Please add setback information for these places. Setbacks should be measured from property lines.
In addition, see Planning Memo for additional landscaping/buffering requirements outlined within the Town's Multiple-Family Design Standards.

SETBACK DIMENSIONS ADDED AND PLANNING MEMO COMMENTS HAVE BEEN ADDRESSED BY THE LANDSCAPE ARCHITECT.

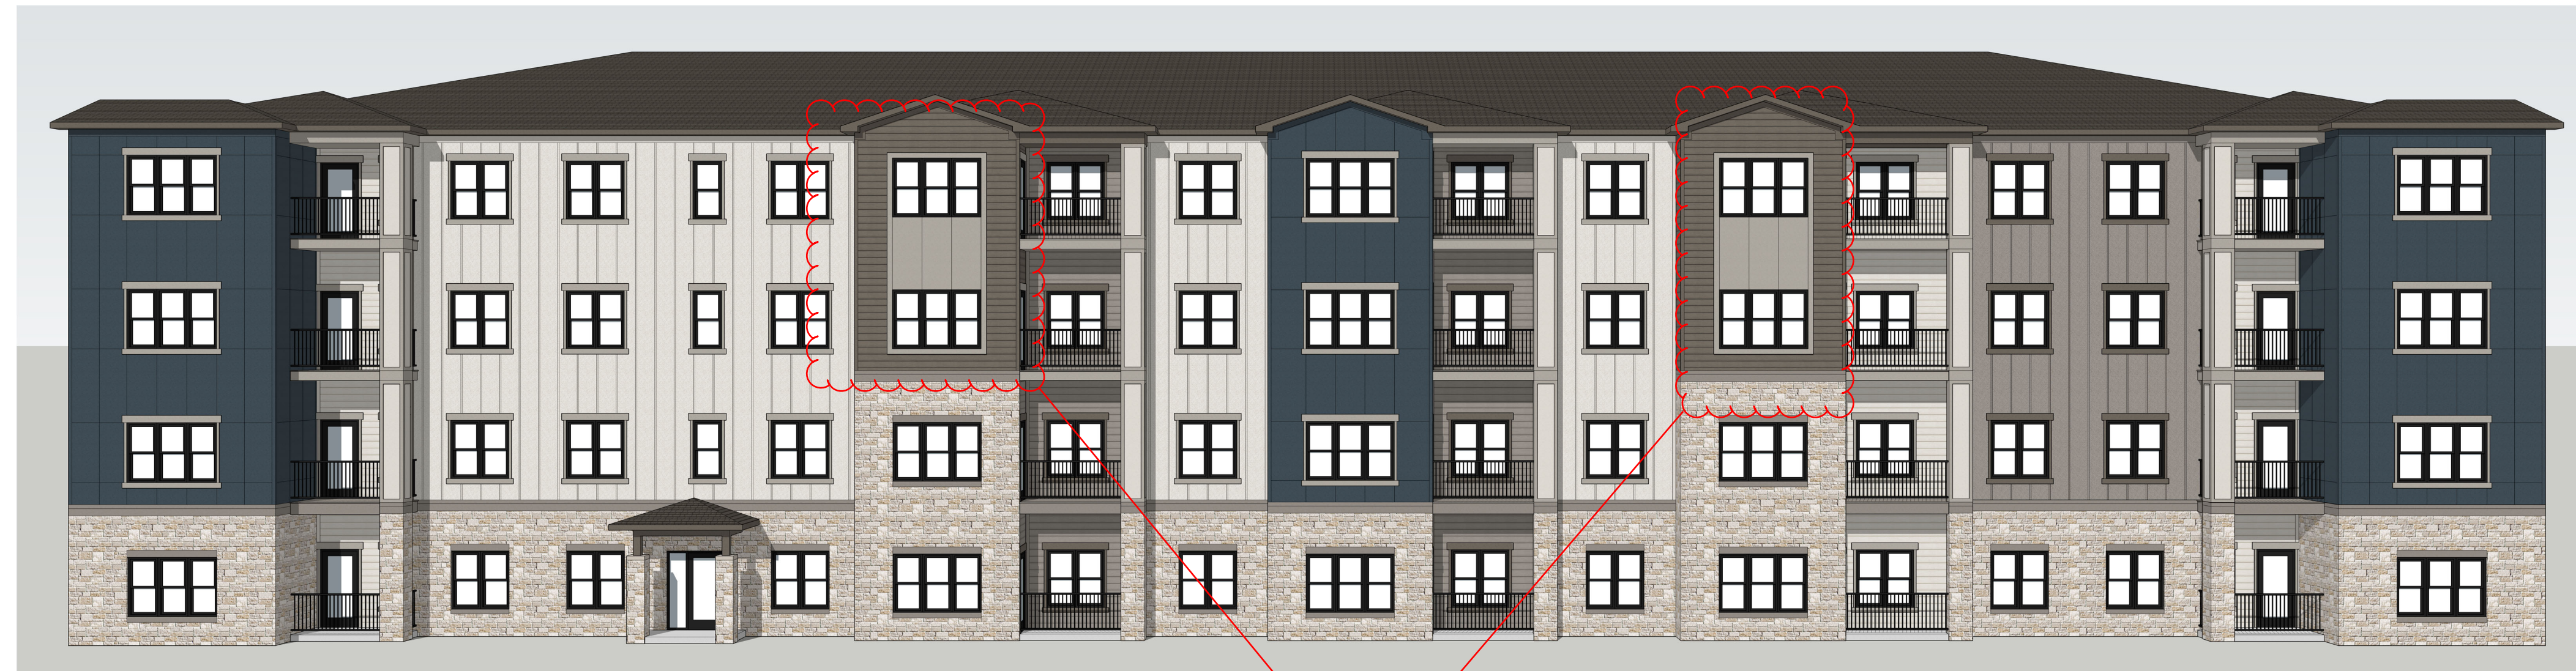
SB RESPONSE: Building 2 elevations have been redesigned and a different color palette used. See revised elevations and responses in planning memo

SB RESPONSE: Building 2 elevations have been redesigned and a different color palette used. See revised elevations and responses in planning memo

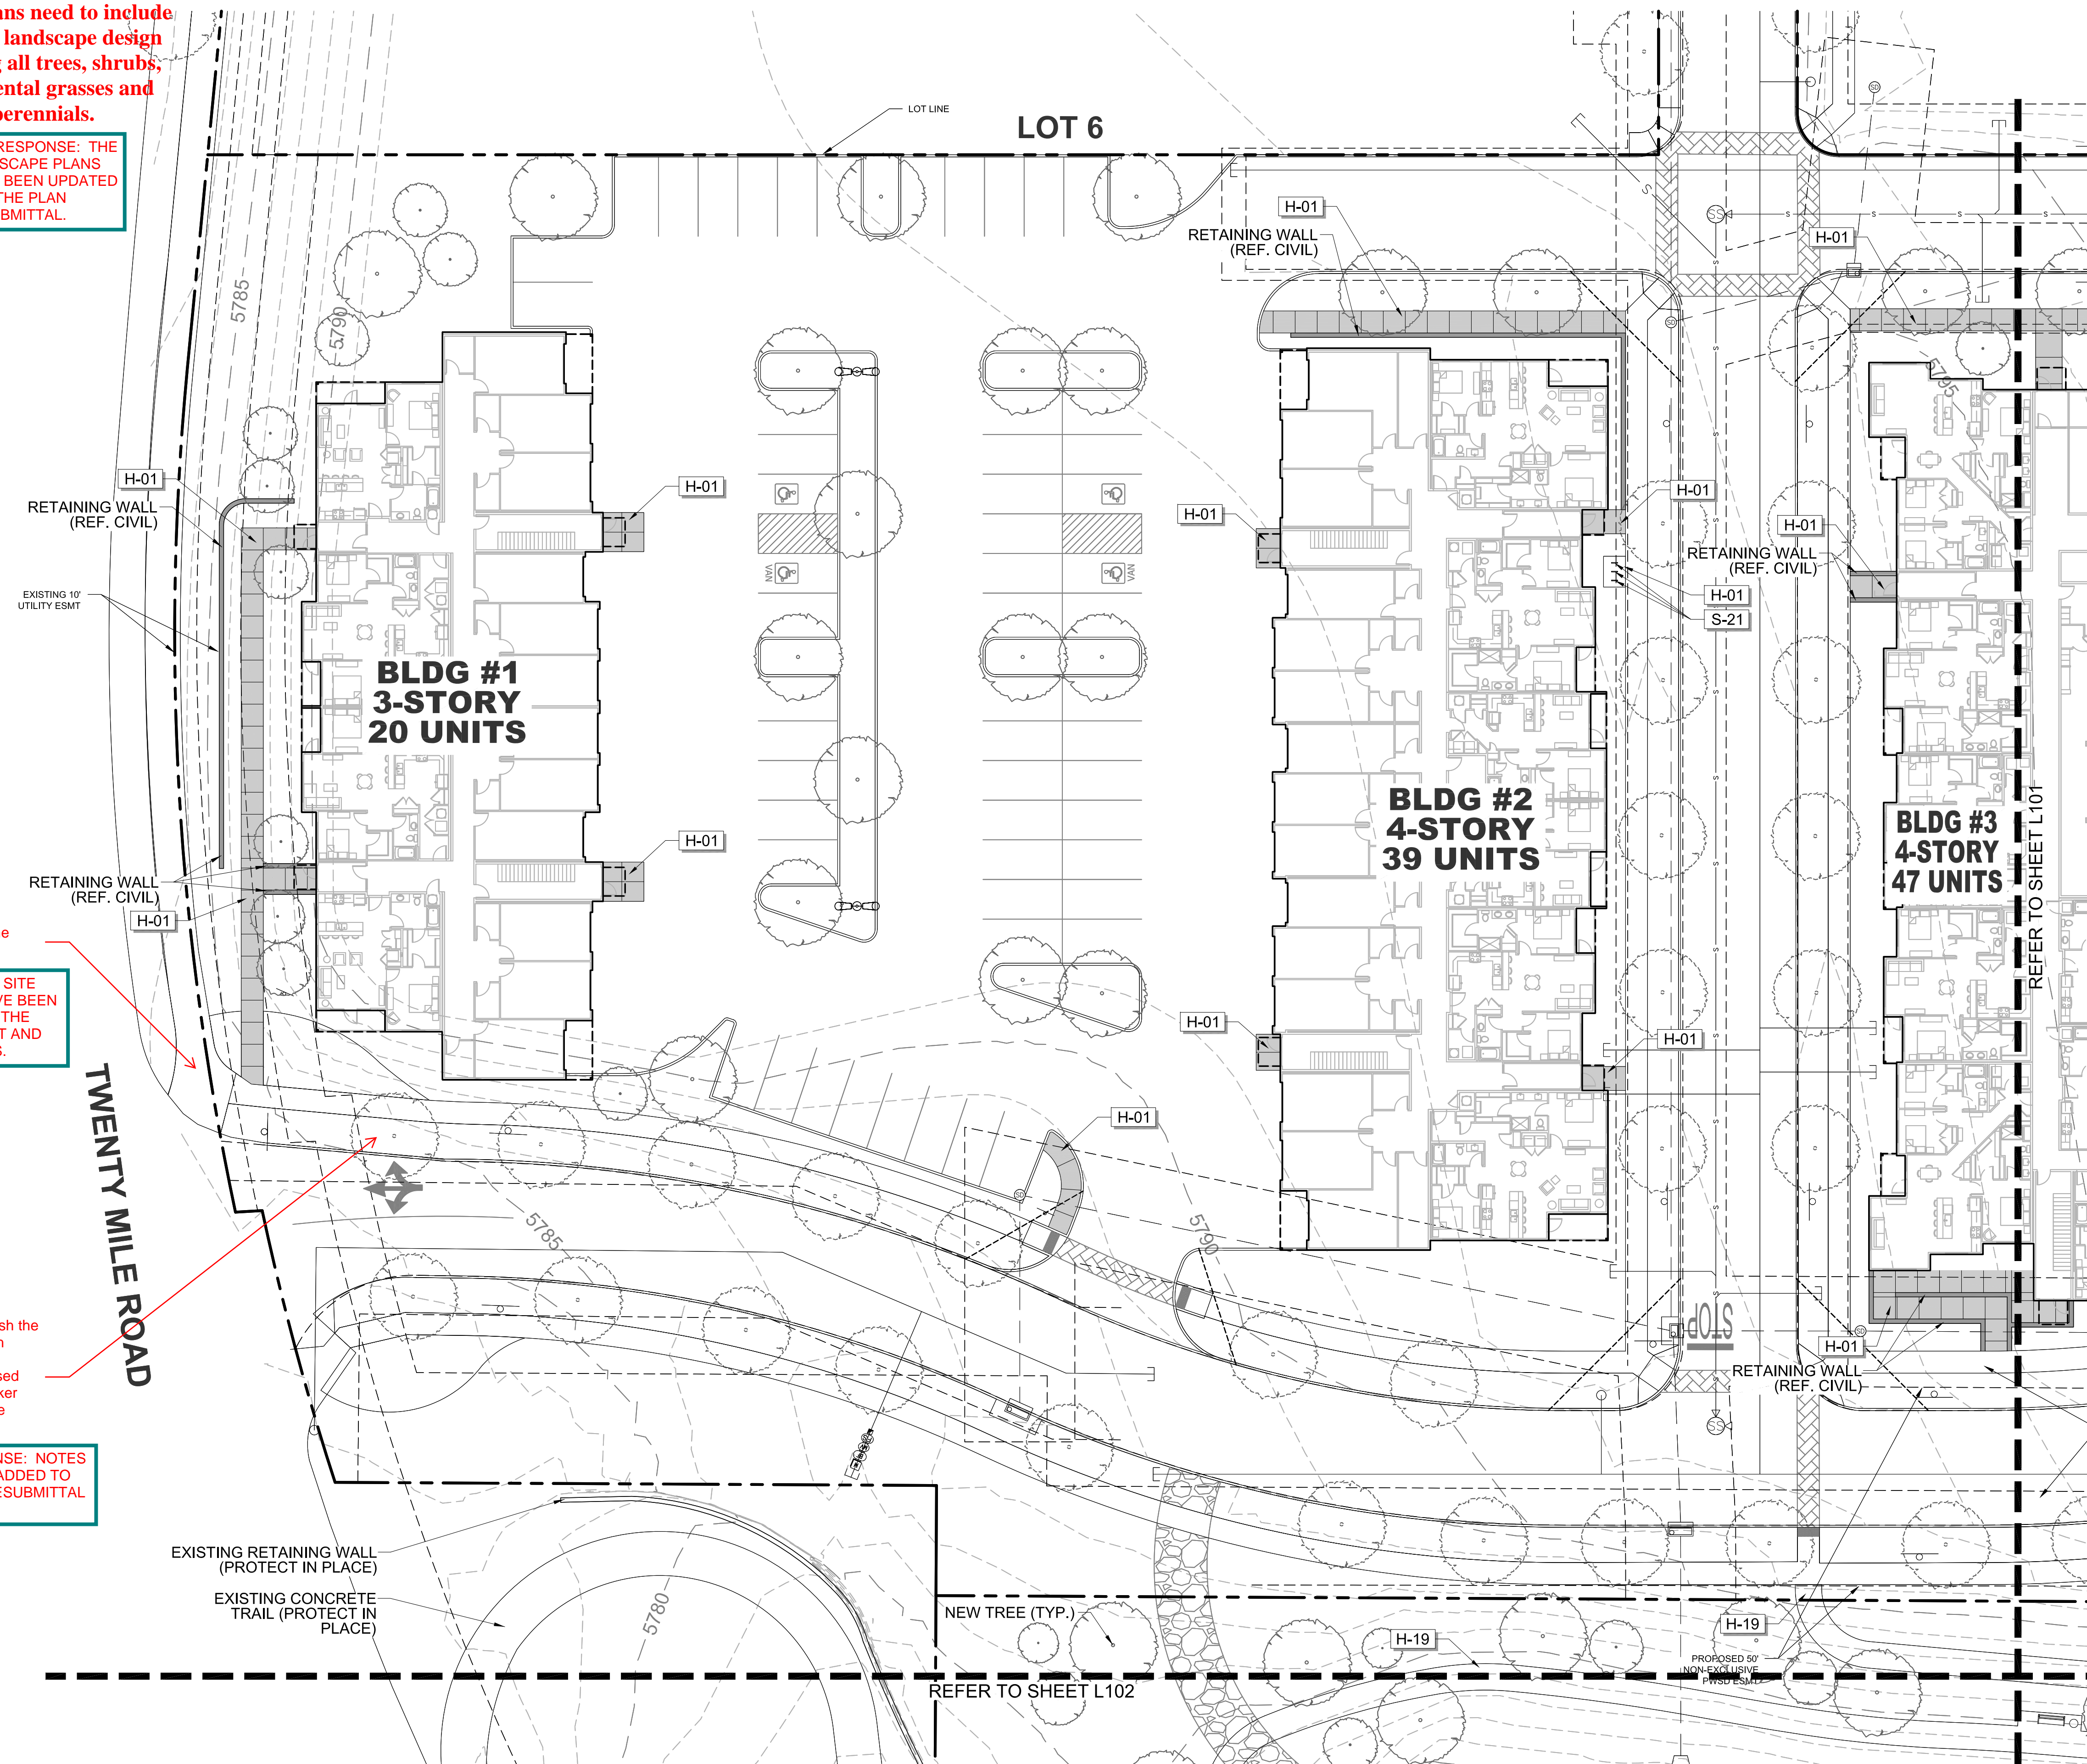
TGC RESPONSE: THE LANDSCAPE PLANS HAVE BEEN UPDATED FOR THE PLAN RESUBMITTAL.

TGC RESPONSE: SITE EASEMENTS HAVE BEEN CALLED OUT ON THE SITE PLAN SHEET AND LANDSCAPE CDS.
